Florida Department of Transportation

ADDENDUM NO. 1

FINANCIAL ITEM NUMBER: 415474-2-52-01, 415474-2-52-02, and 415474-2-56-01
CONTRACT NUMBER: E3U76
DESCRIPTION: Design Build for SR 30 (US 98) Brooks Bridge No. 570034

This is your authorization to make the following changes to the Request for Proposal package you now have for the subject project:

Figure 3: Lighting Design and Construction – West of Bridges

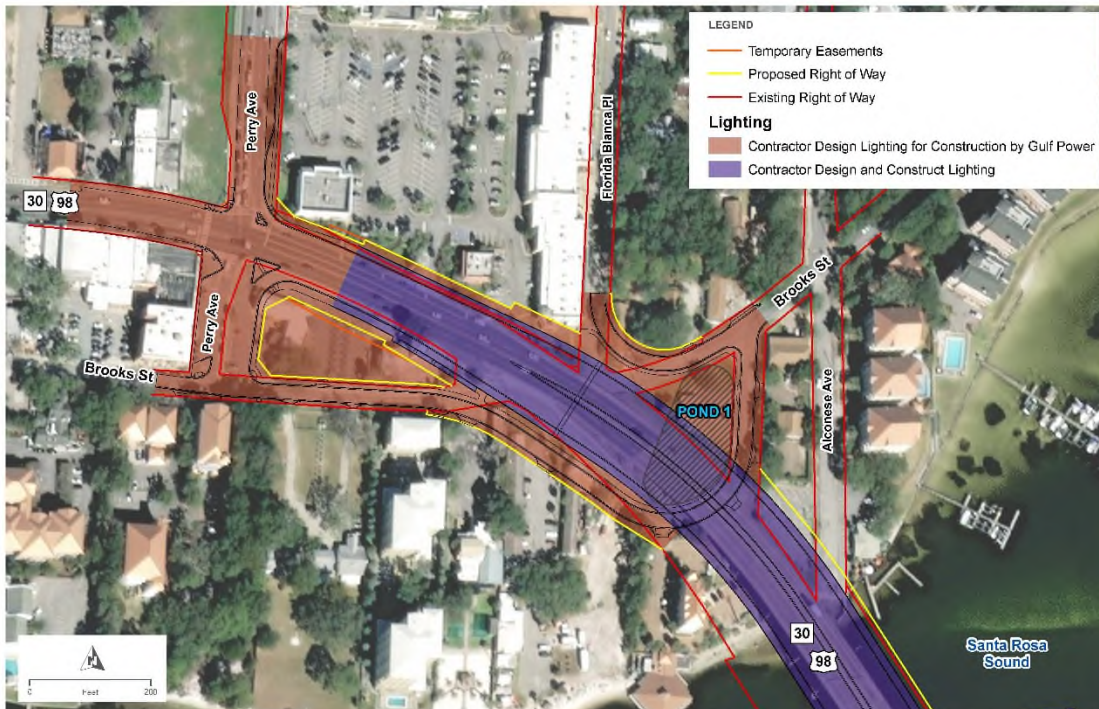
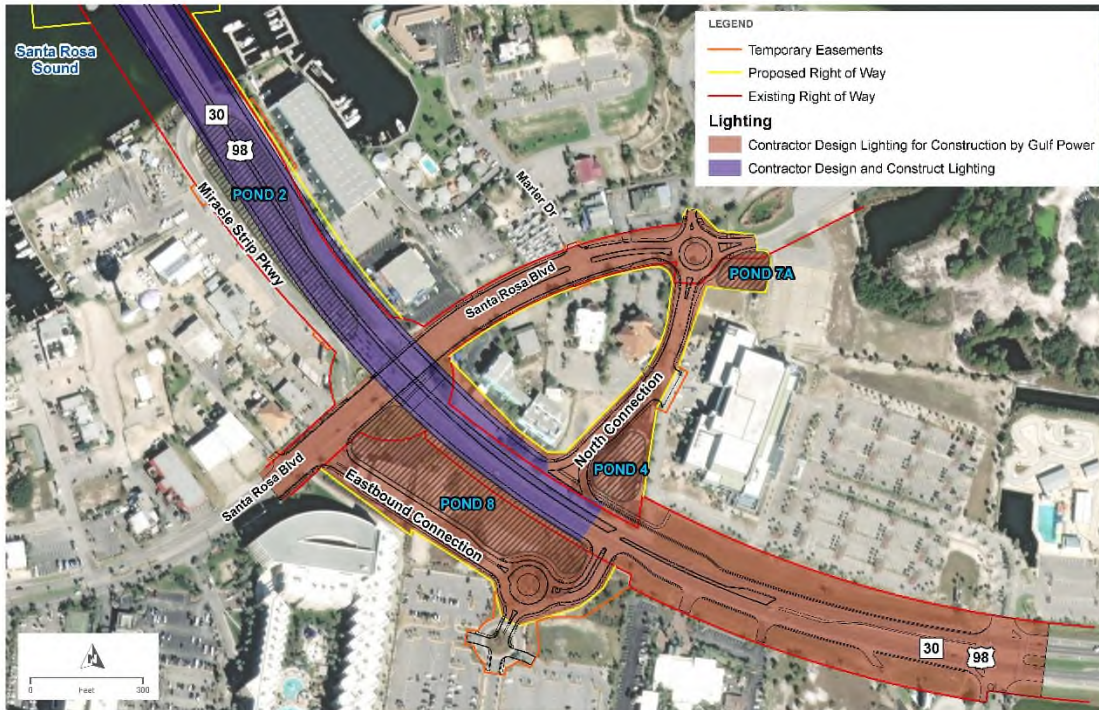
- Section I. Introduction**, under “Description of Work”, Lighting
- Clarified requirements

- Section I. Introduction**, under “Description of Work”, Aesthetics, Roadway Lighting
- Clarified requirement

The Design-Build Firm shall design and construct lighting along SR 30 within the limits of the new bridges and approaches within limits of retaining wall. Lighting constructed by Design Build Firm shall meet aesthetic requirements defined in the RFP. The Design-Build Firm shall design and construct the underdeck lighting for the portions of the project where US 98 is elevated at Santa Rosa Blvd. and at Brooks Street.

The Design-Build Firm shall design all remaining lighting which will be constructed by Gulf Power. See Figures 3 and 4 below depicting the approximate limits of lighting design and construction west and east of the proposed bridges. There is existing lighting on SR 30, Brooks Street, Florida Blanca Place, and Santa Rosa Boulevard. The Design-Build Firm will be required to coordinate and complete the design/replacement/relocation of any lighting on these streets disturbed during construction. The Design-Build Firm shall coordinate design of the lighting to be installed by others with Gulf Power. The Design-Build Firm shall also coordinate with the City of Fort Walton Beach and Okaloosa County, as appropriate.

The proposed lighting is to be **typical** FDOT Conventional Lighting of the Light Emitting Diode (LED) type with full cutoff distribution to reduce sky glow as much as possible. High mast lighting is not allowed on this project.

The existing lighting in conflict with the proposed design shall be removed. **Temporary lighting shall be provided if existing lighting is removed prior to installation of proposed lighting.** The Design-Build Firm shall remove lighting in conflict and stockpile on site for the Department's contamination contractor to remove from the project. Contact the District Contamination Coordinator at (850) 330-1511.
